RESOLUTION HOLDING HEARING ON REQUEST FROM HUBBELL REALTY COMPANY (OWNER), REPRESENTED BY CALEB SMITH (OFFICER), FOR REVIEW AND APPROVAL OF PUD FINAL DEVELOPMENT PLAN FOR “GRAY’S STATION TELUS CONDOS,” FOR PROPERTY LOCATED IN THE VICINITY OF 1300 TUTTLE STREET

Communication from the City Plan and Zoning Commission advising that at their February 2, 2023 meeting, the following action was taken regarding a request from Hubbell Realty Company (owner), represented by Caleb Smith (officer), for the following regarding property located in the vicinity of 1300 Tuttle Street:

STAFF REPORT TO THE PLANNING COMMISSION

Conceptual Plan Gray's Station, a Planned Unit Development in the City of Des Moines, County of Polk, State of Iowa

NEW FRONT ELEVATION

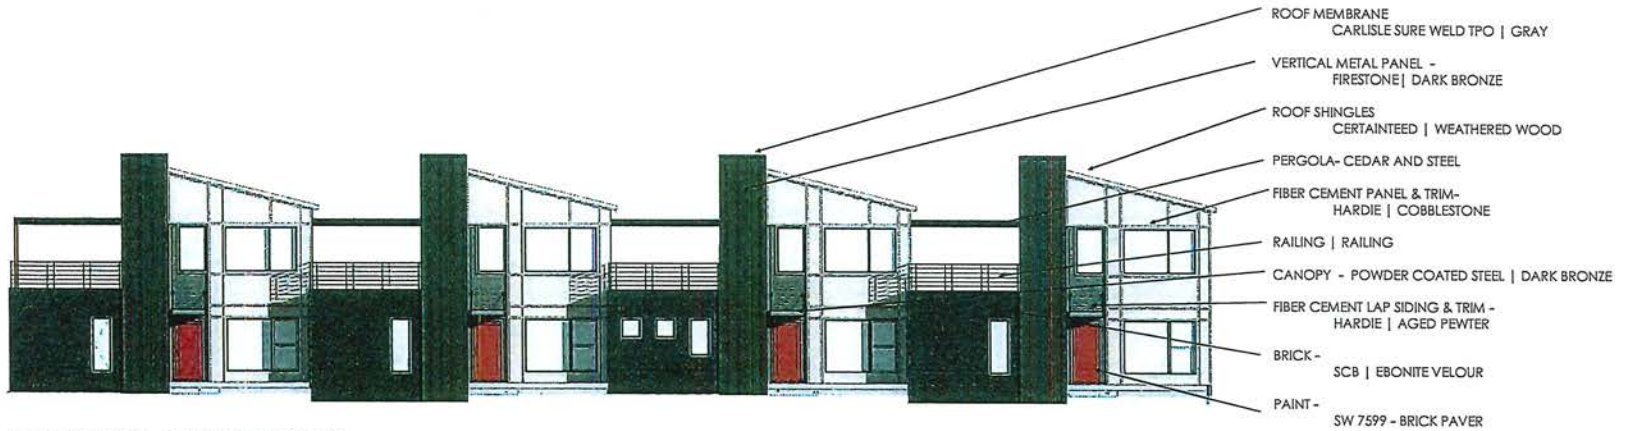
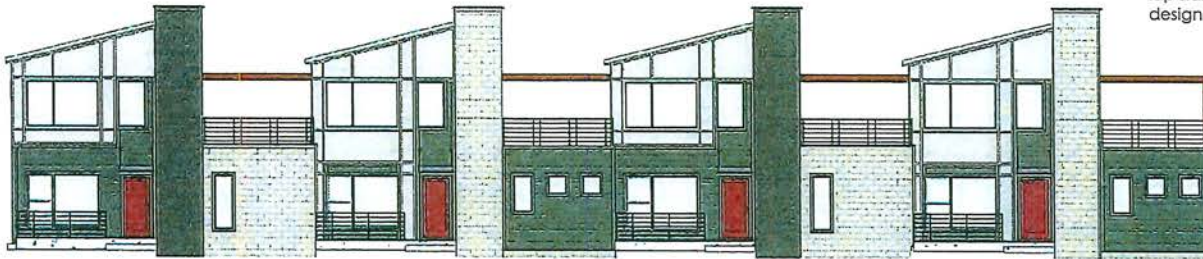
This elevation looked too busy and had too many design themes and variations.

- Revised vertical elements to all be the same color and revised material to dark metal panels with a vertical pattern.
- The cube-shaped building elements were revised from Hardie lap siding/stone to all stone, to unify the overall building design.

NEW FRONT ELEVATION

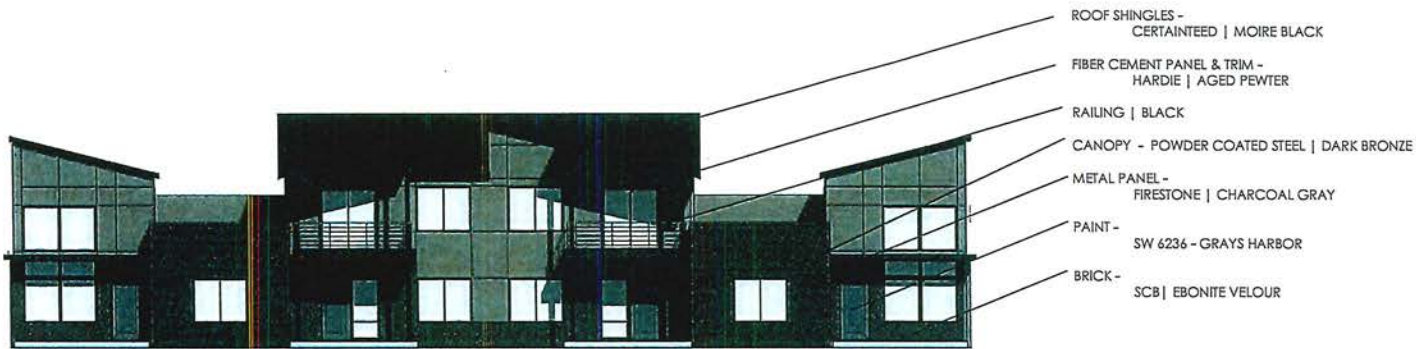
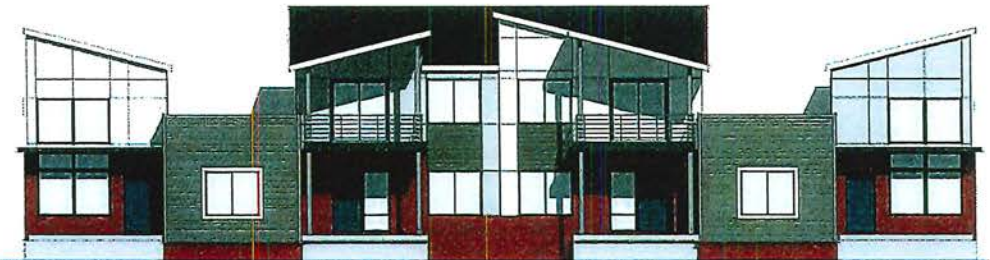
This elevation was too busy and the color scheme too light for this urban environment.

- Changed to a darker color scheme to achieve a more urban look.
- Changed Hardie lap siding on front to metal panels.
- Eliminated the white-colored Hardie panels and matched the panel color on both sides to achieve a unified appearance.
- Steel metal posts will be painted dark gray.
